CITY OF WOODBURN
COMMUNITY DEVELOPMENT

MEMORANDUM

Date: June 8, 2020
To: Dago Garcia, P.E., City Engineer
Cc: Chris Kerr, AICP, Community Development Director
Roy Hankins, PE, Emerio Design
From: Colin Cortes, AICP, CNU-A, Senior Planner *cc*
Subject: **Planning Division review comments on original / 1st submittal of civil engineering plans for Smith Creek Development Phase 3B**

Attachment 3
Sheet 1 of 2
of **C2.00**

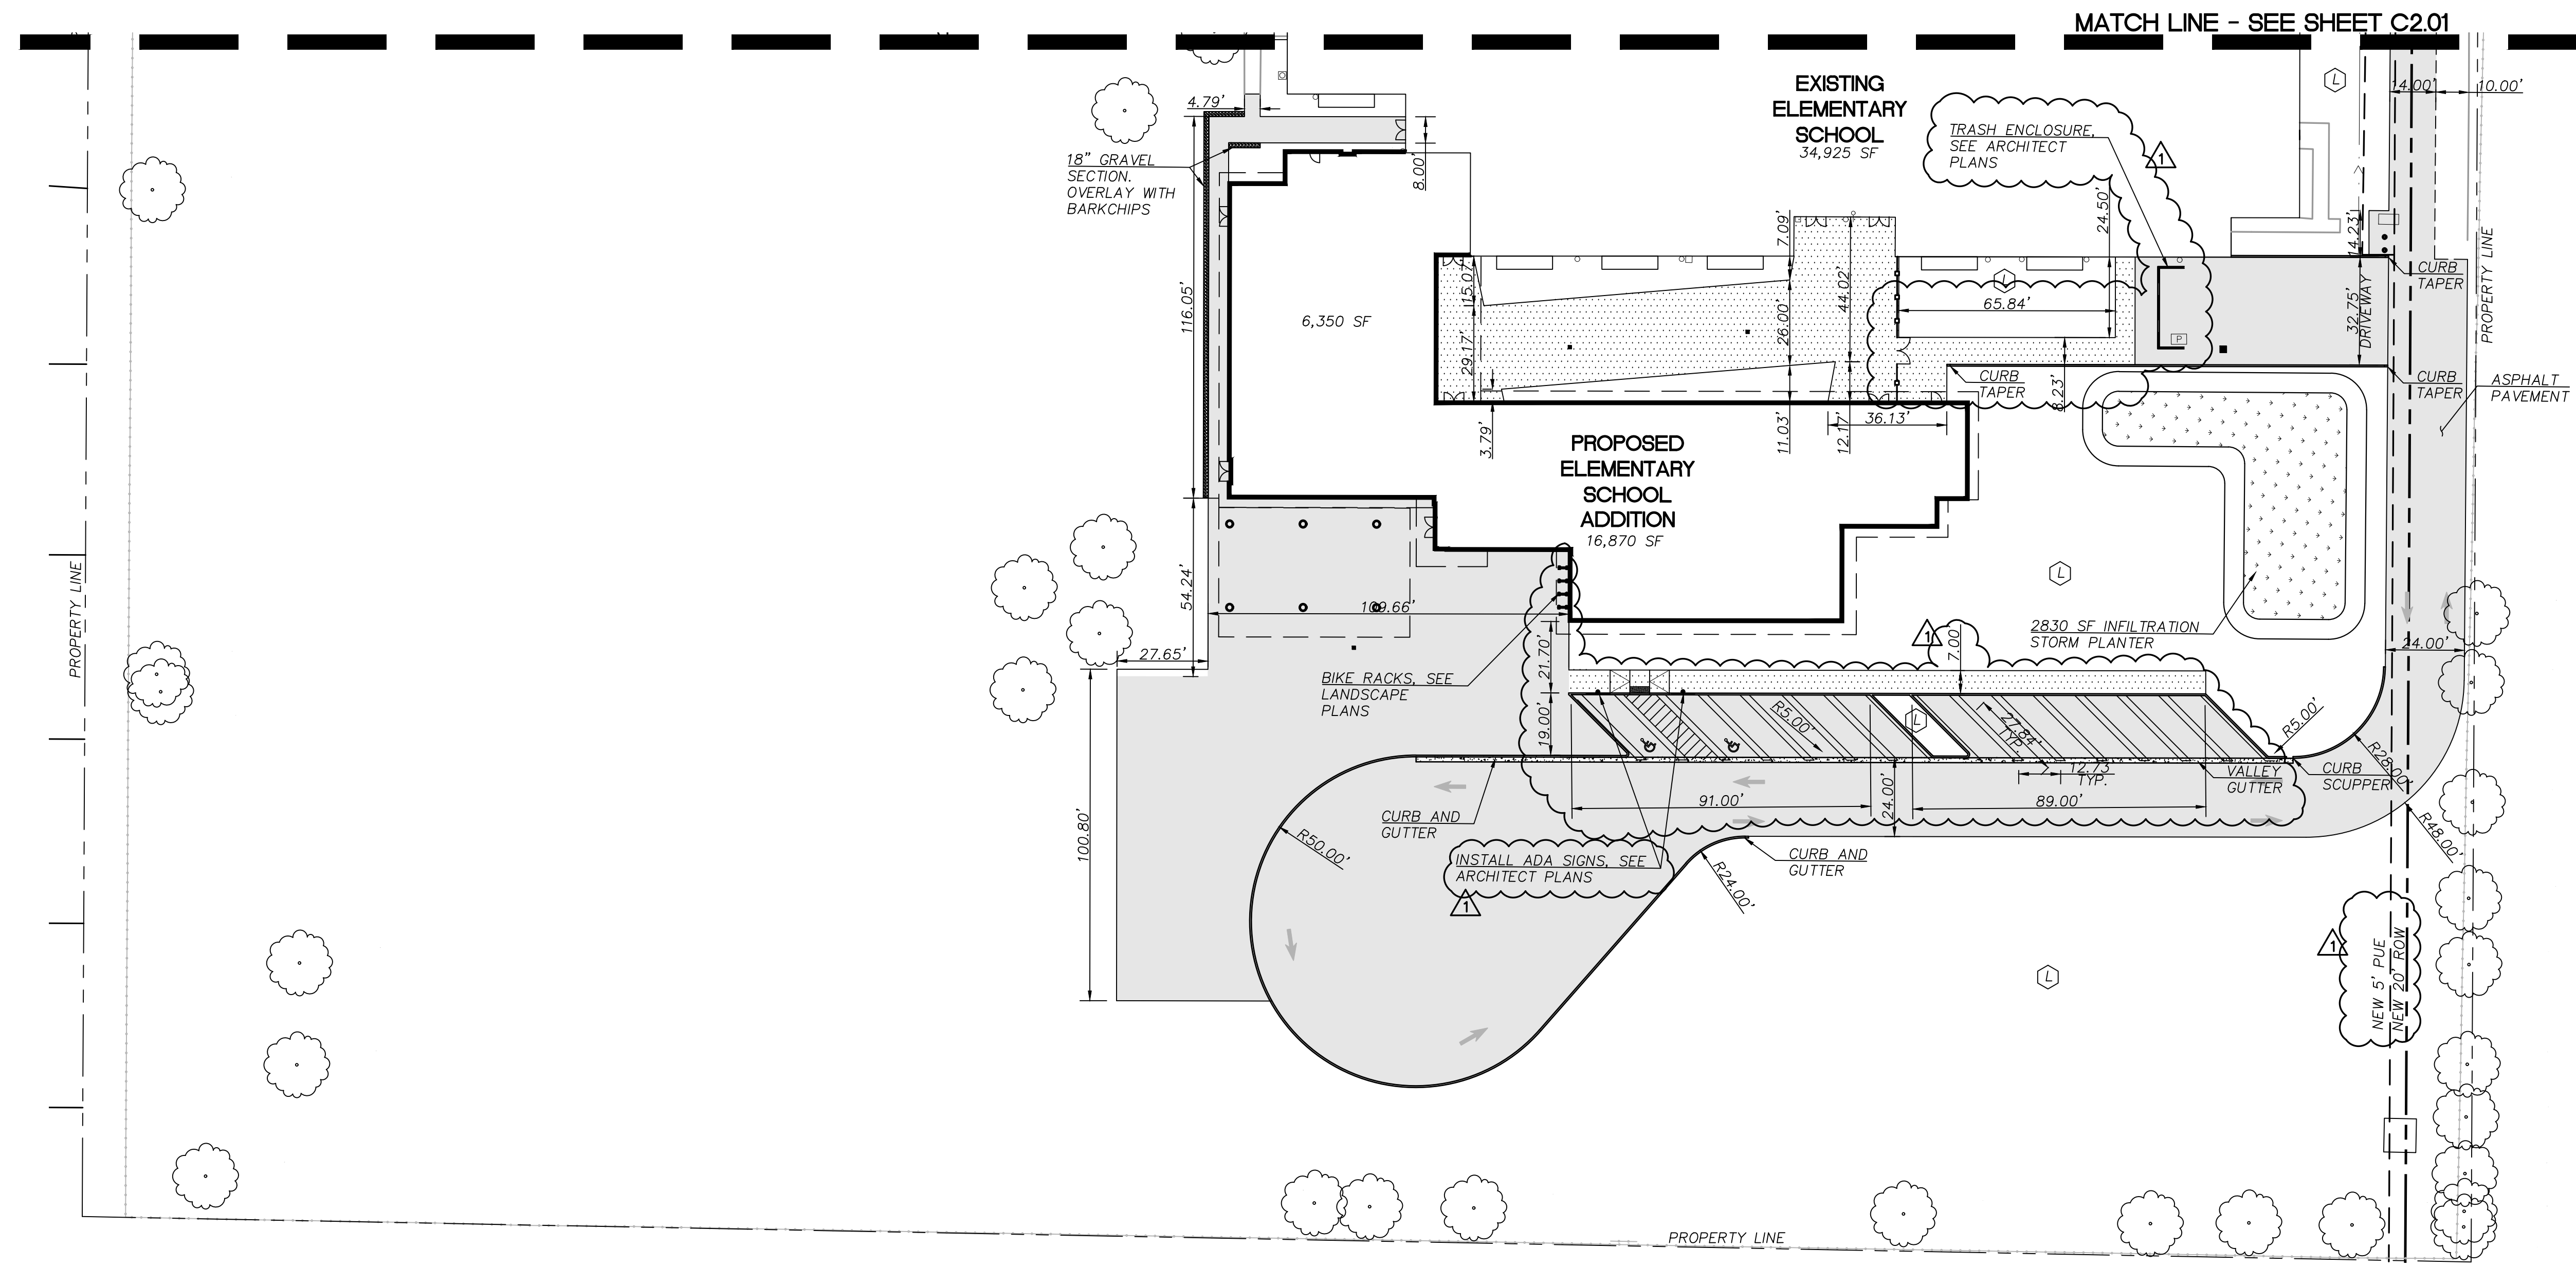
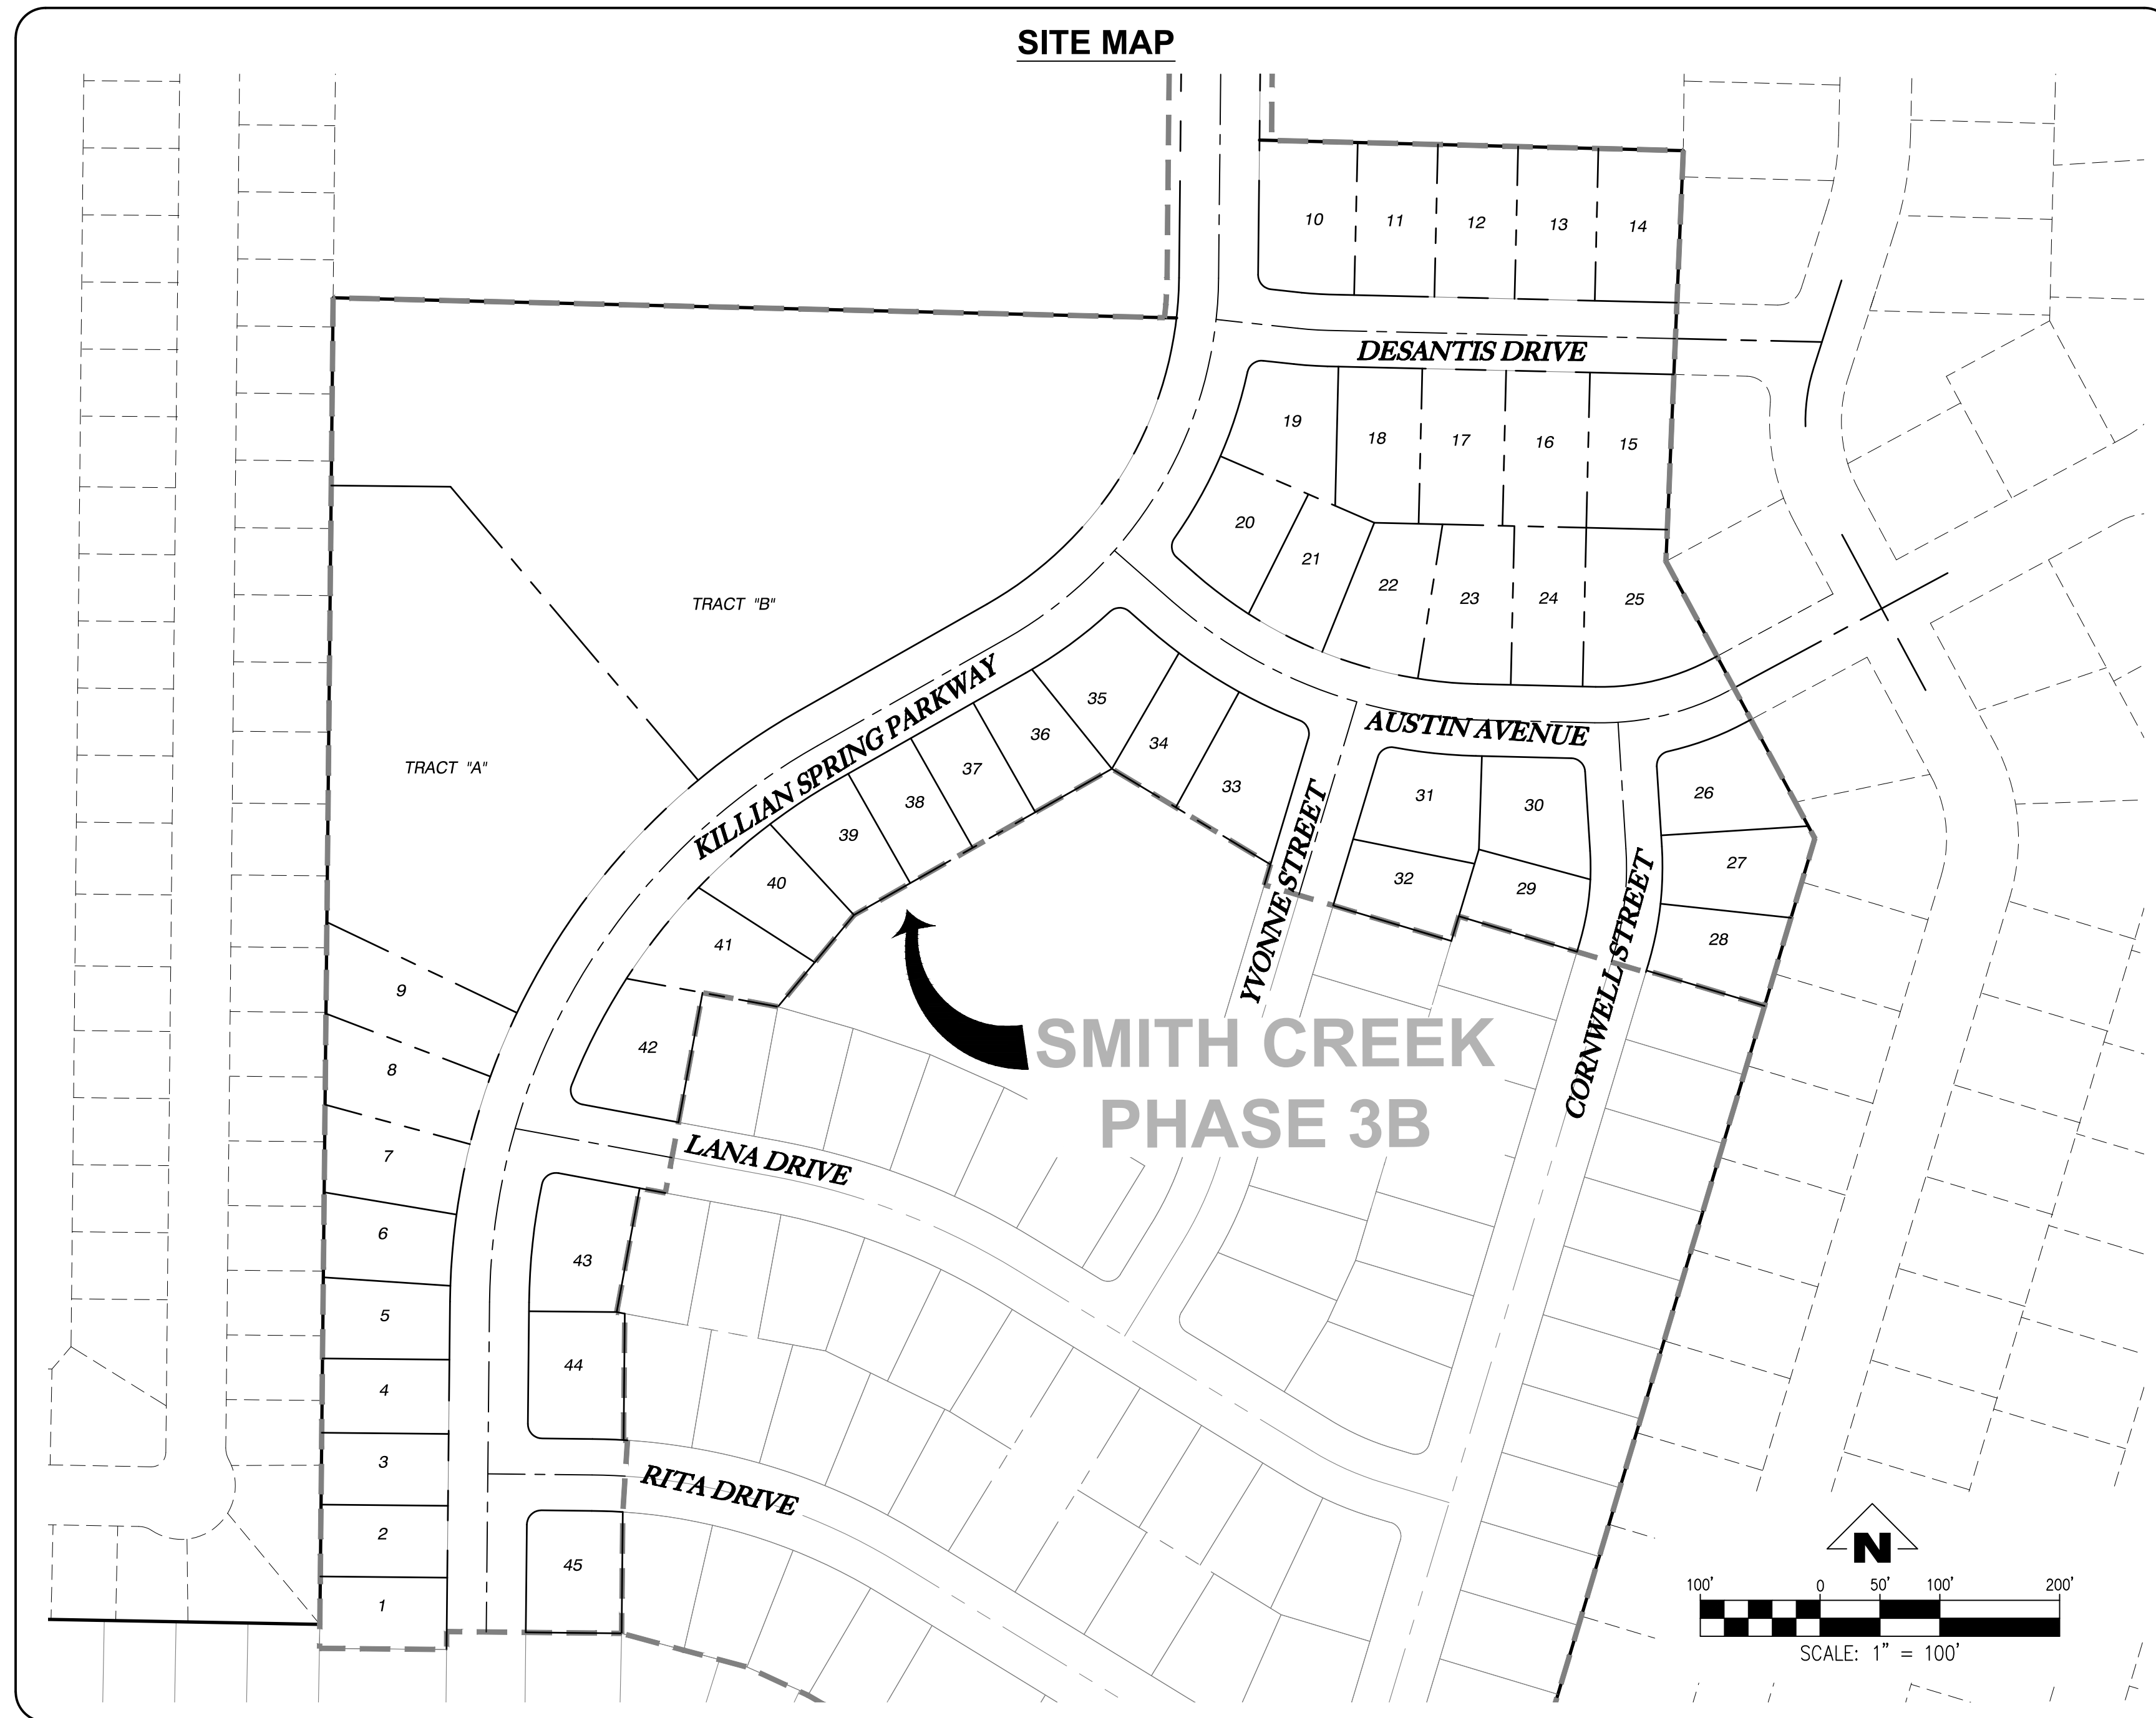
Per the CU 2019-05 civil plans Sheets C2.00 & C2.02 (Attachment 3) there are two drive aisles that, as the City and the school district plan, will be truncated with two driveways upon construction of Killian Spring Drive upon, which would remove the allowed, now-interim private improvements within the 20-ft ROW that the district dedicated.
